**Title: Prostar upper radiator pipe cracking or breaking at support bracket or at flange area**

**Applies To: Prostars built before 8/28/07**

Drawing 1

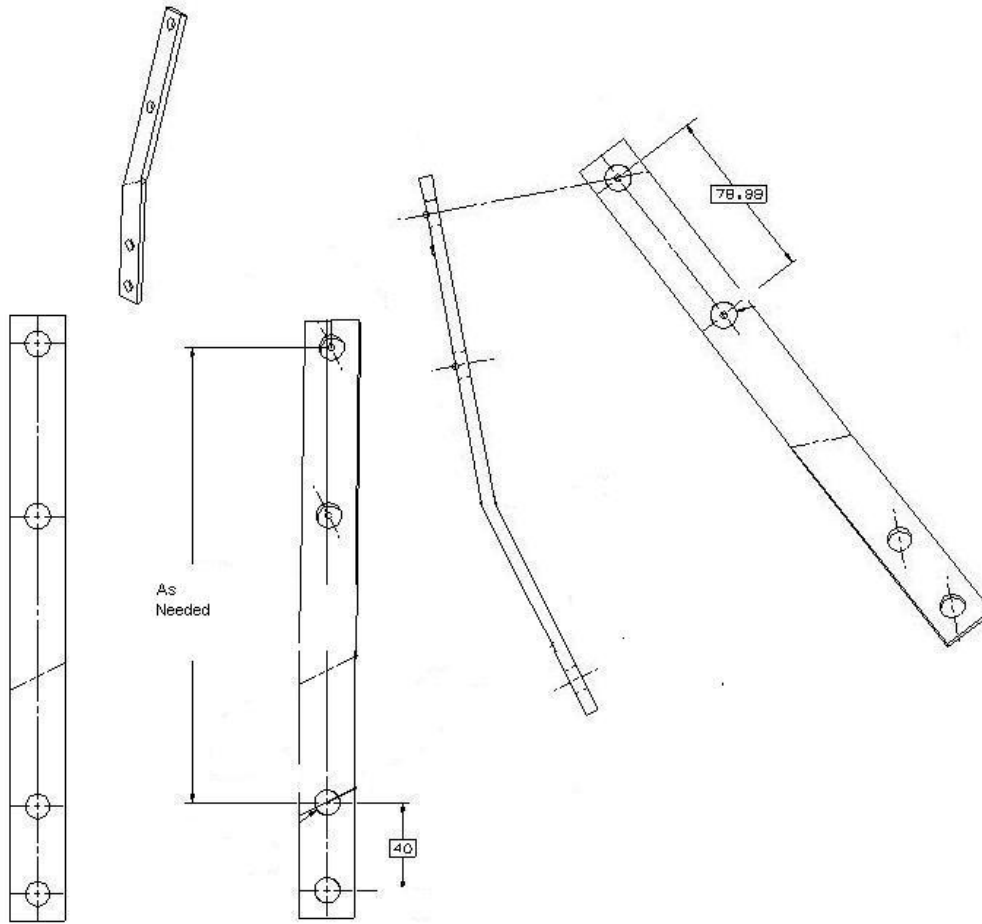
On some ProStar tucks built before 8/28/07 we have seen the upper radiator pipe break either at the support bracket that is welded to the pipe, or at the flange that mates to the engine. The fix is to cut off the support bracket that is welded to the pipe and make a simple bracket out of flat stock similar to drawing 1 below. Bolt the new bracket to the engine and secure the pipe to the bracket with an exhaust u-bolt (471200C1). Make sure to loosen the flange bolts and retighten them after all parts and hoses are loose-fit together and the pipe is secured to the bracket to prevent stress on the support bracket or flange. **This is an interim action to fix as fail until the kit is available.**

Note1: In the near future you will be able to order Kit number 8000893R91 along with New pipe number 3625914C2. This kit will contain the new support bracket, U-bolt, nuts, and washers necessecary to install the new pipe. Keep in mind that the new support bracket will not look like the bracket pictured below.

Kit 8000893R91 includes:

- 1 - 3821475C1 New support bracket
- 1 - 471200C1 U-bolt
- 2 - 25709R1 Washers
- 2 - 359783C1 Nuts
